# 5.2. MATERIAL CHANGE OF USE FOR SHOPS AT 24 MACROSSAN STREET PORT DOUGLAS

REPORT AUTHOR Jenny Elphinstone, Senior Planning Officer

APPLICATION NO MCUC 2021\_4256/1

PROPOSAL Material Change of Use (Shops)

# SITE PLAN 1:100 SCALE1:100

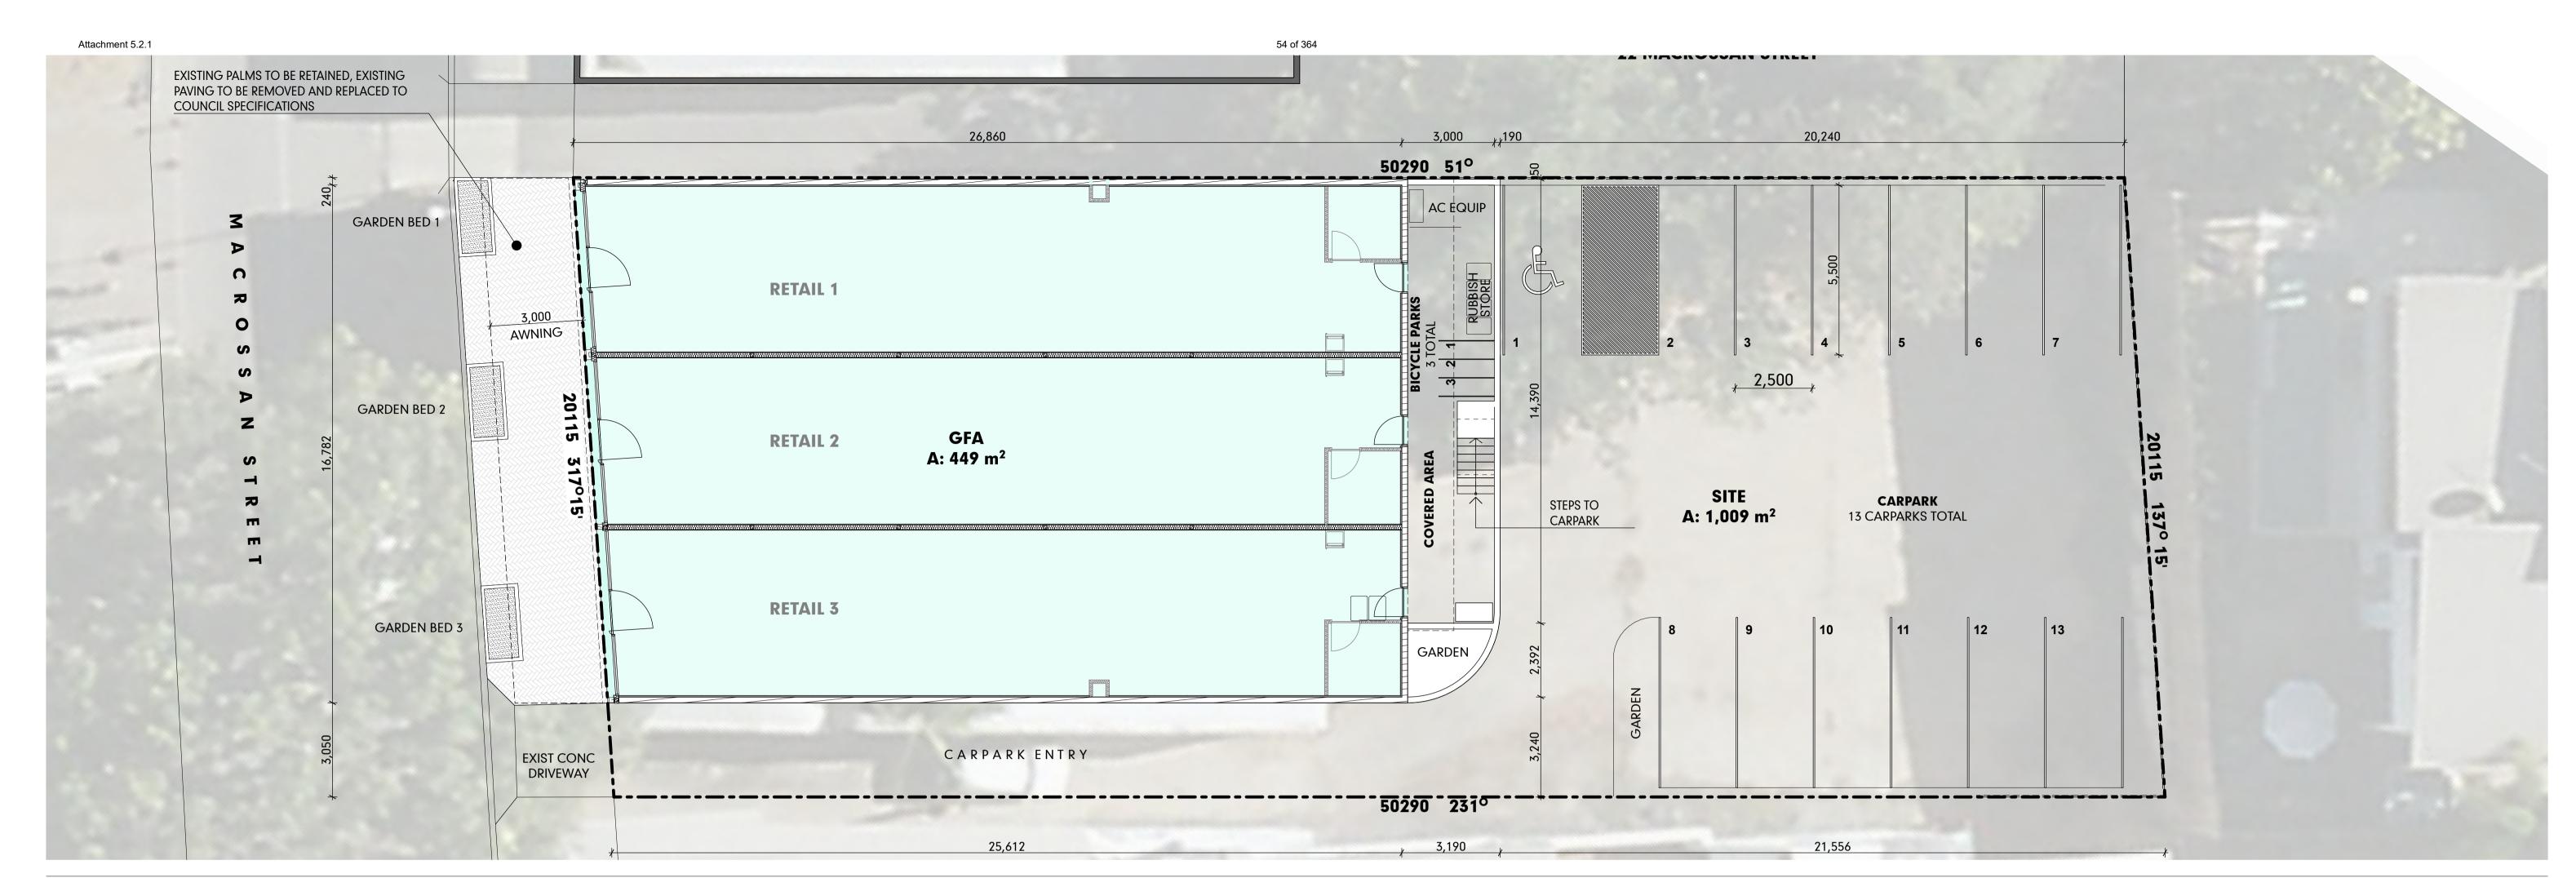
- a. Include the provision of five (5) bicycle parking spaces;
- b. Include a loading bay in the car parking area to accommodate a single larger vehicle space of a SRV (small rigid vehicle as in AS2890.2 off-street commercial vehicle facilities but incorporating a body width of 2.33m);

- c. Amend the driveway width to ensure suitable access can be achieved for the required service vehicle in Condition 3b above;
- d. Include a pedestrian access along the side driveway that connects the disability car parking space at the rear of the new building with the front entrance of the new shops. This pedestrian access must meet all relevant Australian Standards including separation between pedestrians and vehicles, hand-rails and ramping;

- e. Include a splay of the front corner of the building to the driveway to provide suitable visibility;
- f. Maintain car parking for ten (10) car parking spaces, including one disability car parking space, all meeting the relevant Australian Standards;

- g. Include lighting to the car parking and access driveway;
- h. Include a sign at the front of the premises advising of the location of car parking at the rear of the premises;

- Clearly state the intention to retain and replace specific existing palms, as per the Landscaping Plan, on both the Site Plan - Existing & Demolition and the Site Plan - Proposed;

Details of the above amendments must be endorsed by the Chief Executive Officer prior to issue of a Development Permit for Building Work.

# LANDSCAPE PLAN

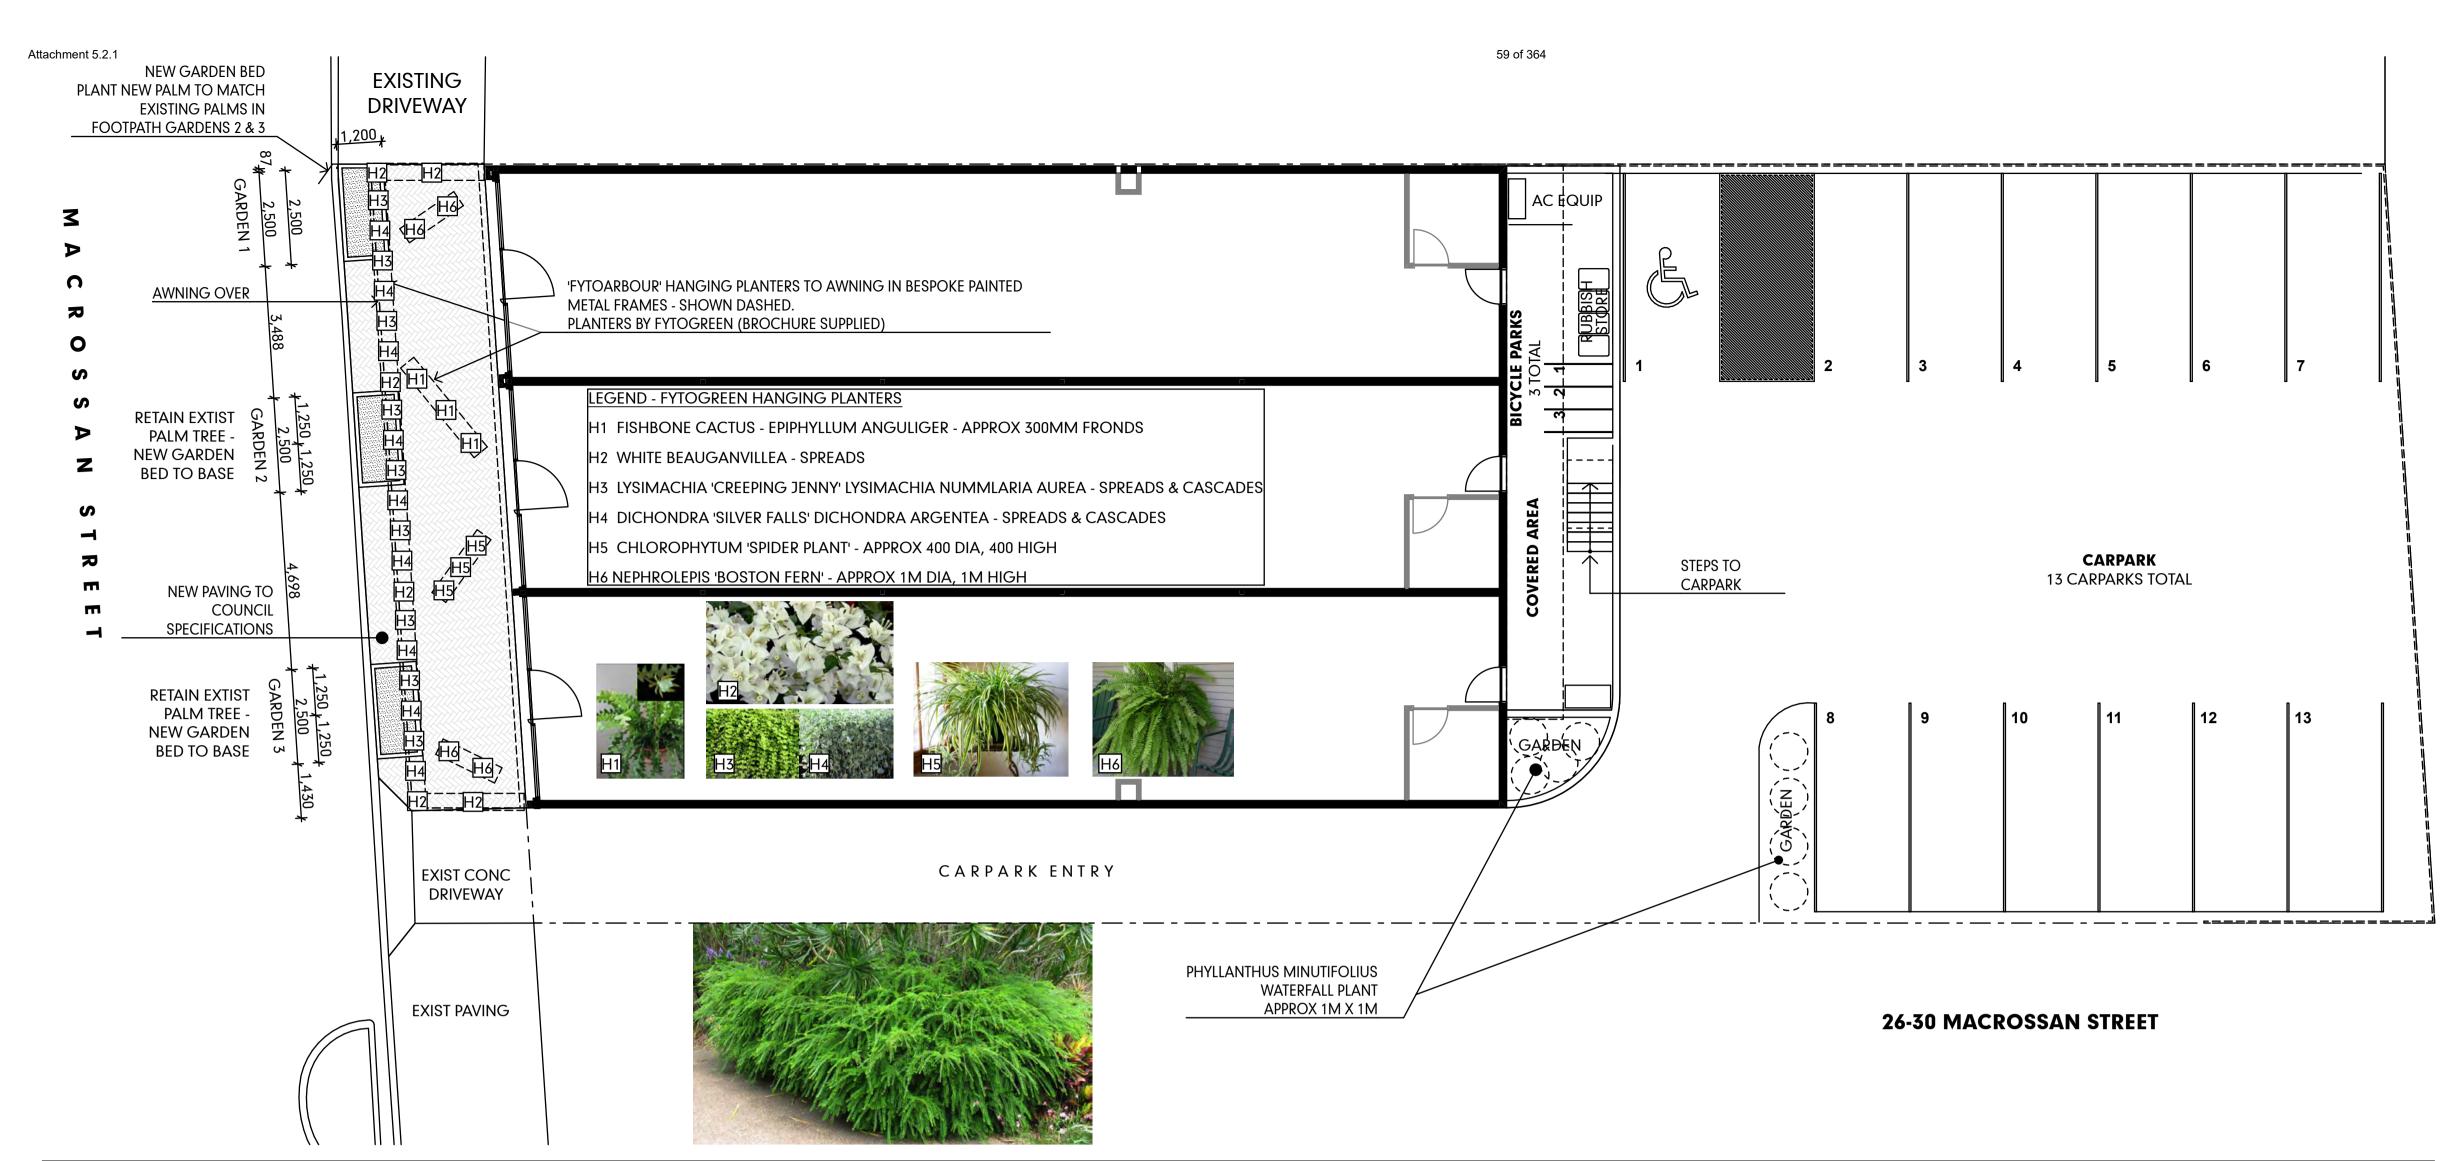
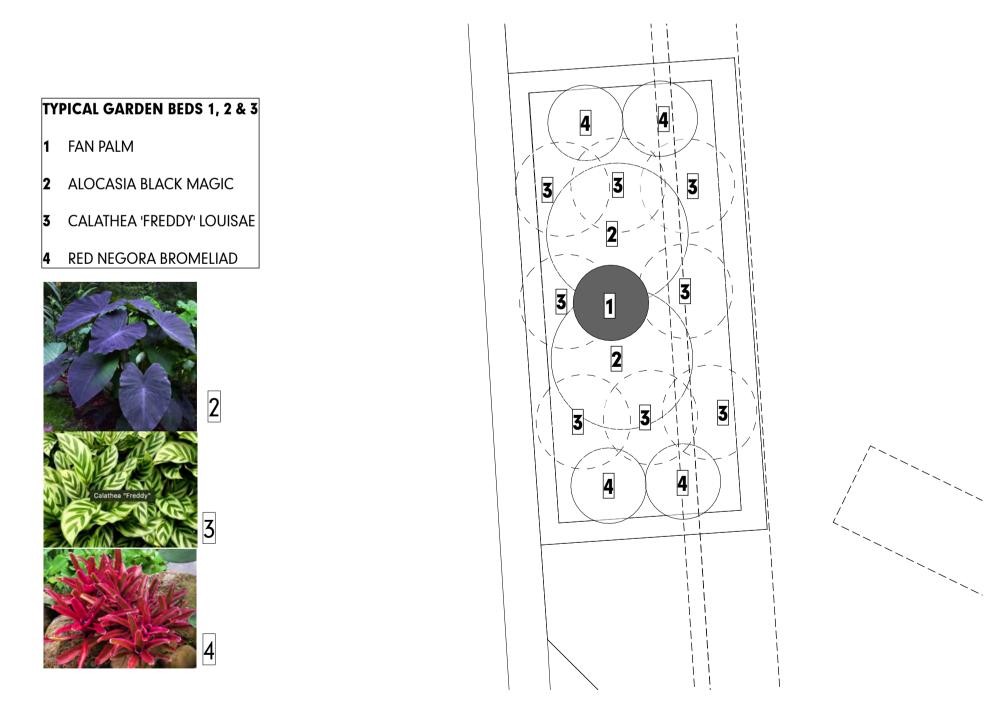
- j. Specify the pavers *Wirecut Acorn* to be used in the footpath with a pattern to match that in the street; and
- k. The refuse bin area must be roofed and bunded and fitted with a bucket trap.

- 5. Undertake the following works external to the land at no cost to Council:
  - a. Construct a footpath to Macrossan Street in accordance with the proposed Landscape Plan (as amended by Condition 3) and the FNQROC Regional Development Manual having regard to the use of Wirecut Acorn pavers in a design that matches that occurring in the street.
  - b. Provision of a new concrete crossover and apron in accordance with FNQROC Development Manual Standard Drawing S1015; and
  - c. Construct landscaped garden beds as per the approved landscape plans;
